Shearon Harris Nuclear Power Plant, Unit 1  
Docket No. 50-400/Renewed License No. NPF-63

Subject: Response to Request for Additional Information #4 Regarding License Amendment  
Request to Revise Technical Specification Table 3.3-4 Loss of Offsite Power 6.9 kV  
Emergency Undervoltage Primary Setpoints (TAC No. MF4294)

Response to Request for Additional Information #4  
License Amendment Request to Revise Technical Specification Table 3.3-4  
Loss of Offsite Power 6.9 kV Emergency Undervoltage Primary Setpoints

**CHART A1-1**  
**BUS 1A-SA VOLTAGE DURING SEQUENCING**  
**(At Switchyard Voltage Limit - 222.00 kV)**

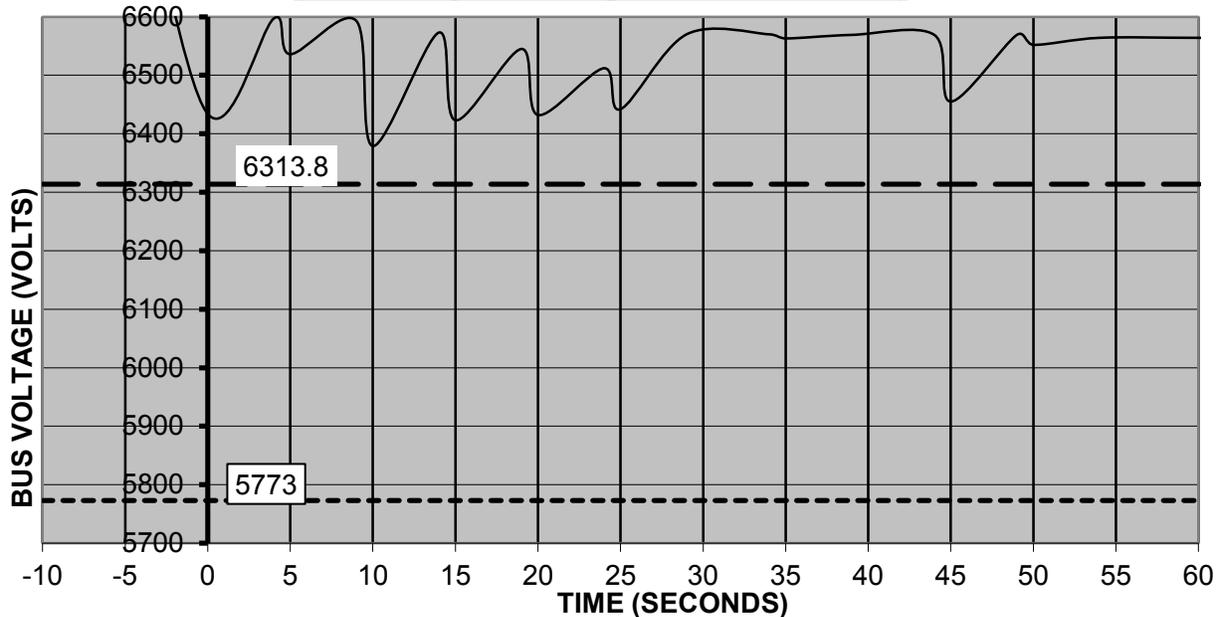
In the calculation No. 0054-JRG attached to LAR, the licensee calculated a maximum pickup/reset value of LOV as high as 105.23 V. The licensee stated that a pickup value of 105.23 V is acceptable because it is less than the minimum degraded voltage relay dropout setting of 106.73 V.

The staff finds the pickup (reset) voltage value as 105.23 V of 120 V = 87.7 percent very high, which does not provide an adequate margin from the degraded voltage relay dropout setting of 106.73 of 120 V = 88.9 percent. The staff considers that the analytical and reset voltage values of LOV relay should be lower than the minimum voltage calculated at the 6.9 kilovolts (kV) safety-related buses during starting of LOCA sequencing loads any time after the safety injection signal, based on the minimum switchyard voltage (after the unit trip). Please provide a curve showing the minimum voltages at the 6.9 kV safety-related buses during 55 seconds of starting of LOCA loads after the safety injection signal based on the minimum switchyard voltage. Super-impose on this curve the analytical and reset voltage values of LOV relay settings to confirm that adequate margin exists so that the motors would not trip out by the LOV relay during LOCA loads sequencing.

Chart A1-1, shown on page 6 of this enclosure, was developed using Chart A1-1 out of E-6000, Revision 12. This chart was initially developed to demonstrate adequate margin for the DGV settings which are higher than the LOV settings. The DGV values from this table were then replaced with the LOV values to develop a similar plot to show the LOV setting as compared to the LOCA response profile. From this graph, it is shown that the voltages seen during LOCA sequencing are well above the LOV dropout and pickup values. Chart A1-1 shows that there is adequate margin and the LOV setting would not be reached during a LOCA at the minimum switchyard value.

Note: The chart above is for the A train. The B train is similar and the conclusions are the same, so only one representative graph is being provided. The worst-case voltage dip considering both trains is down to 6370 V (during Load Block 3 on Bus 1B-SB).
